Access Compliance Report

Public Rights-of-Way

(Curb Ramps)

Intersection ID: 52448	Main Street: WOODWARD_AV	Cross Street: DOUBLE_OAKS_RD	Location: SW
ADA ID: AE64A10C4D92	Ramp Type: Directional1	Initial Pass/Fail: Pass	Overall Compliance: No
Severity Score: 15.25			
Codes/Mitigation Info/Possible Solution		Field Measurements/Component Compliance

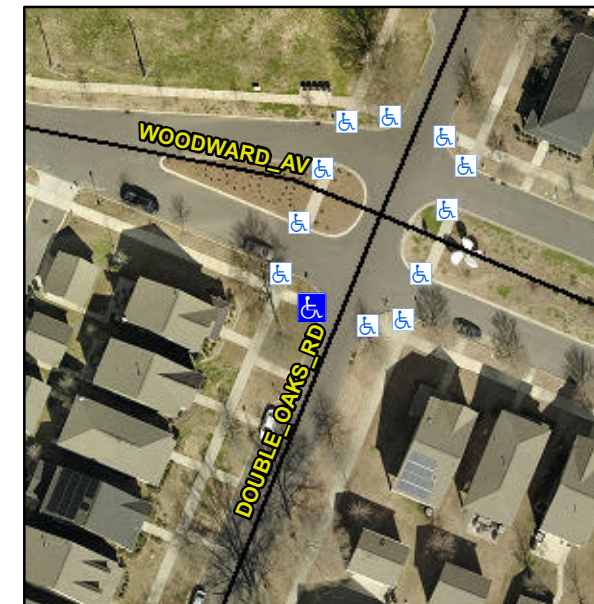
**R304.5.3, R304.2.2-Perp, R304.3.2-
Para, R302.7.2**

Compliance	Description	Data	Compliance	Description	Data
N/A	Ramp Length (in)	79.0	Yes	Grade Break?	Yes
Yes	Ramp Width (in)	72.0	Yes	Grade Break Slope (%)	4.0
Yes	Ramp Slope (%)	3.2	No	Grade Break XSlope (%)	2.8
No	Ramp XSlope (%)	2.7			
Yes	Flare Type LT	N/A	Yes	Flare Type RT	N/A
N/A	Flare Slope LT (%)	N/A	N/A	Flare Slope RT (%)	N/A
N/A	Flare Traversable LT?	No	N/A	Flare Traversable RT?	No
Yes	Landing Length (in)	75.0	Yes	DWS Provided?	Yes
Yes	Landing Width (in)	76.0	Yes	DWS Contrast?	Yes
No	Landing Slope (%)	2.3	Yes	DWS Length (in)	24.0
No	Landing X Slope (%)	2.3	Yes	DWS Full Width?	Yes
N/A	Landing Curb? (Y/N)	No	Yes	DWS Offset LT (in)	19.0
N/A	Shared Landing?	No	Yes	DWS Offset RT (in)	2.0
Yes	Gutter Ponding?	No	Yes	Gutter Slope (%)	2.0
No	Gutter Lip Ht (in)	1.0	Yes	Gutter X Slope (%)	0.3
N/A	Painted X Walk1?	No		Road Slope (%)	2.6
	X Walk 1 Direction	To E		Road X Slope (%)	0.0
	X Walk 1 Width (in)	N/A		Clear Space?	Yes

**Remove & Replace Entire Ramp.
Grind Gutter Lip.**
